ADDENDA - ADDENDUM NUMBER 1
Section 00 91 13 - Page 1
Yorktown Aquifer - Water-Supply Well RO4
Mainland Water Treatment Plant, Maple, Currituck County, NC

DOCUMENT 00 91 13
ADDENDA
ADDENDUM NUMBER 1

PROJECT: Yorktown Aquifer - Water-Supply Well RO4

PROJECT NUMBER: 165302

FIGURE 4
DATE 4/14/22
REVISED 5/18/22
PROJECT 165302

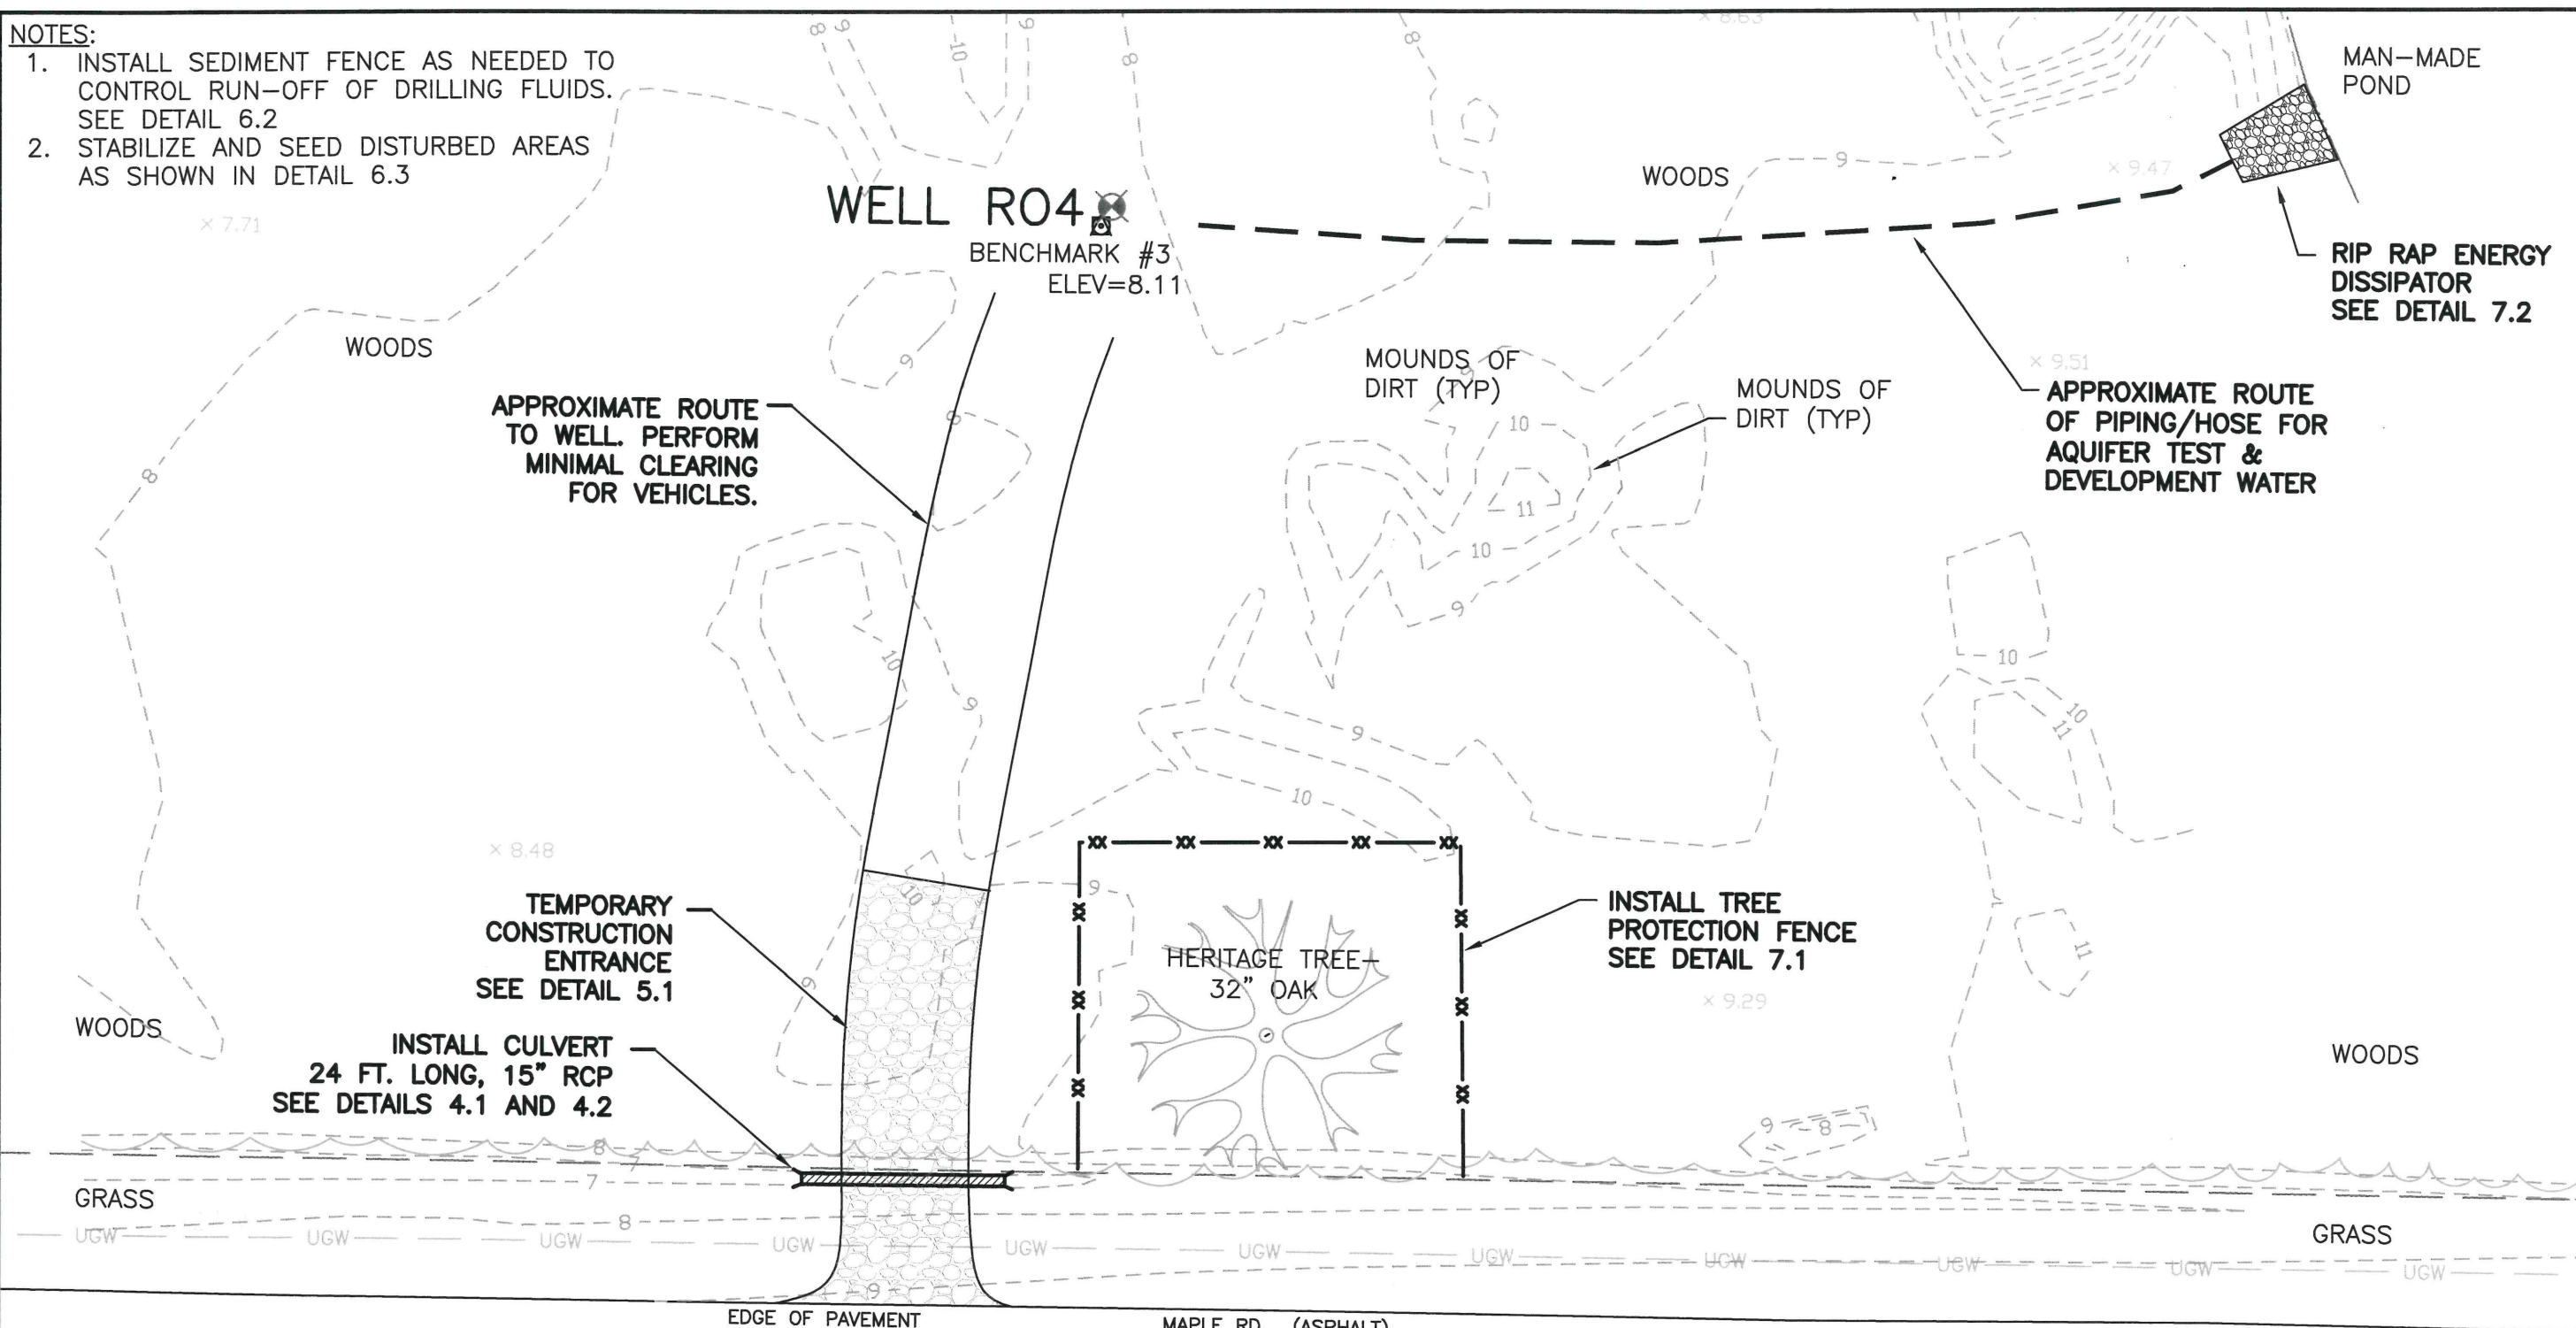
1. **Replace Figure 4 with the attached figure that shows the location of the driveway entrance moved to the south side of the Heritage Tree.**

- b) **Can we move the driveway entrance, and move the well location 25-50 feet to the south, in order to 1.) straighten out the road, while also 2.) reducing the number of large trees that will need to be removed for entrance road construction?** The driveway entrance location is moved to the south side of the Heritage Tree. See revised Figure 4 in Addendum #1. The location of the well is to remain as staked on site (i.e. don't move the well location).

5. Answers to Questions Asked During the Meeting (Questions are shown bold and underlined):
- a) **Can the fencing around the heritage tree be "U" shaped so that the fencing does not encroach into the right-of-way (that tree canopy reaches way out into the road)?** Yes, the tree protection fencing may be installed in a "U" shape. See revised Figure 4 in Addendum #1. The tree protection fencing shall still conform to Figure 7 Detail 7.1.
